**RE: ITB No. 20-102, Blackburn Park Parking Lot Improvements**

**ADDENDUM NO. 2**  
**ITB NO. 20-102**  
**BLACKBURN PARK PARKING LOT IMPROVEMENTS**

CONCRETE WHEEL  
STOP  
NTS

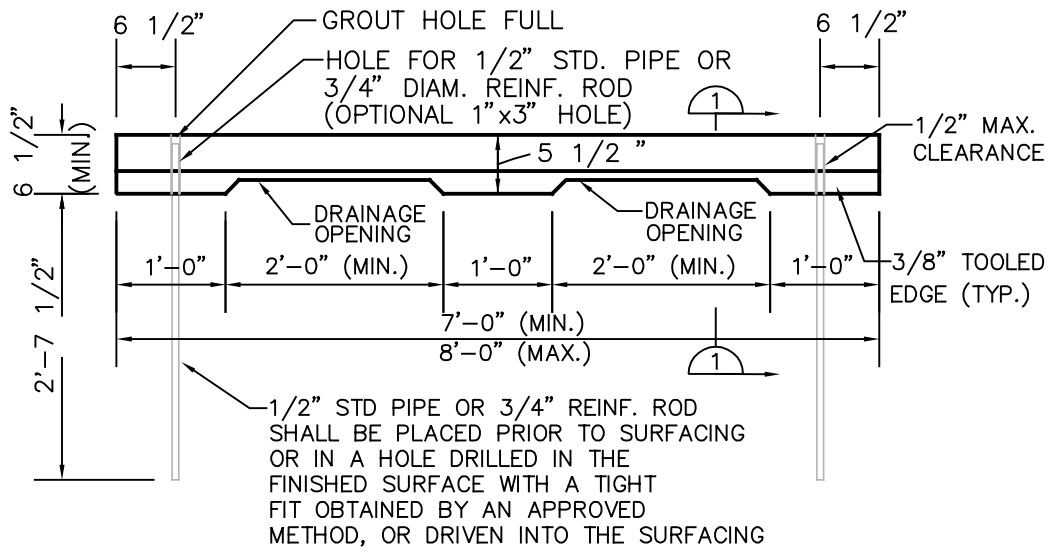
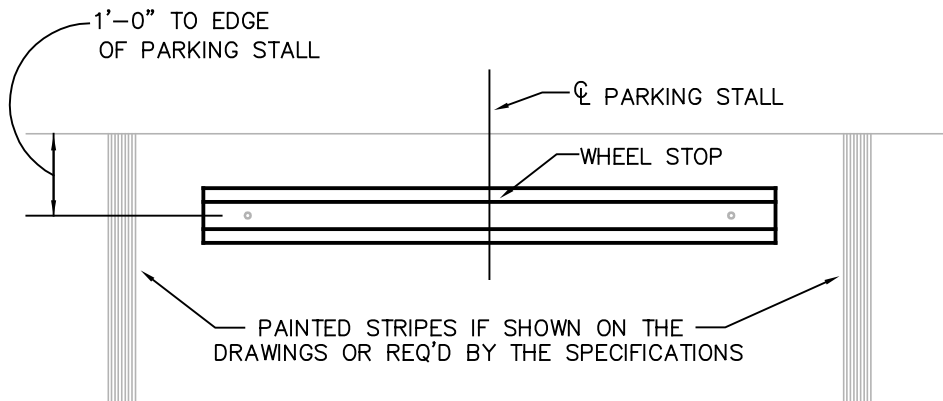
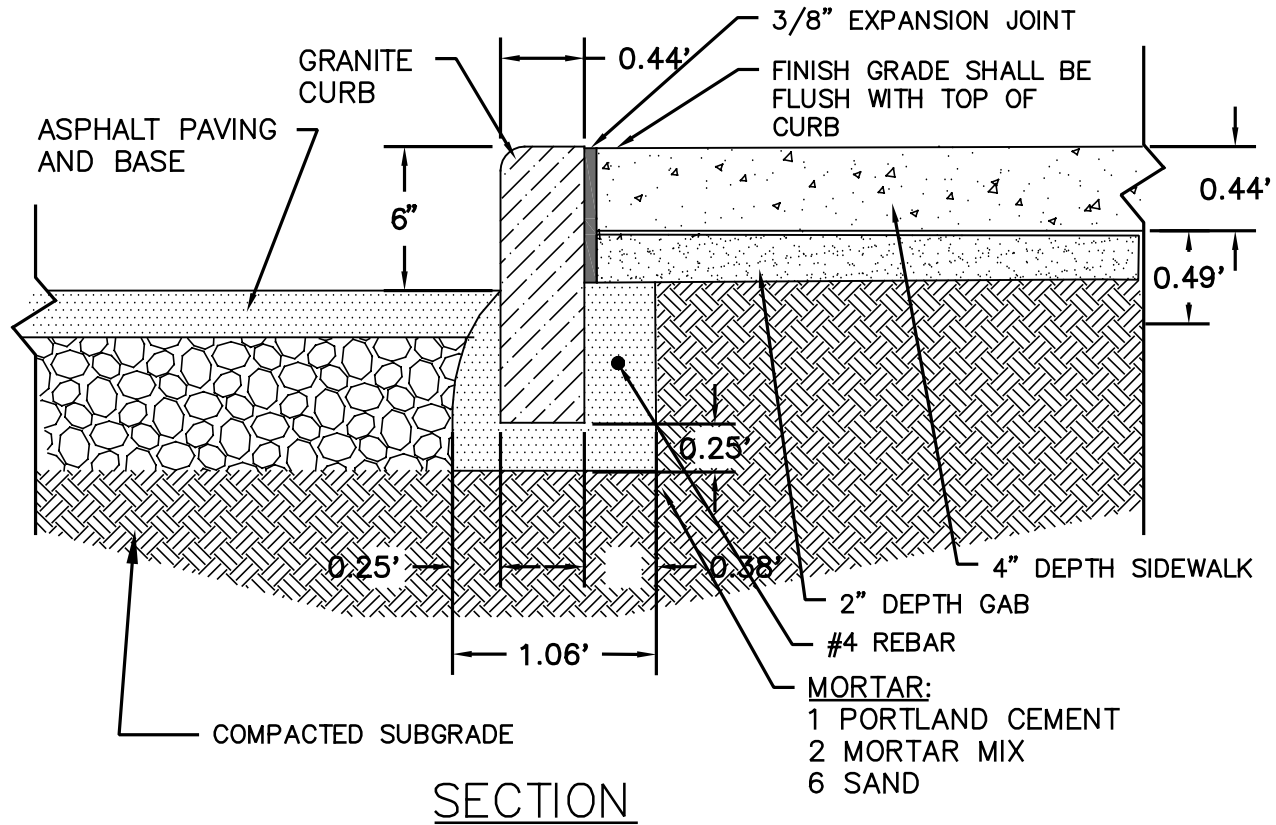
6. Revised detail 7/SD5 is attached. The final height of exposed curb was corrected to 6".
7. Wheel stops have been added to the CIBS. See Item 16. They will only be added to the park side of the south entrance parking lot. See attached Concrete Wheel Stop detail. (add 16, ea to the CIBS)
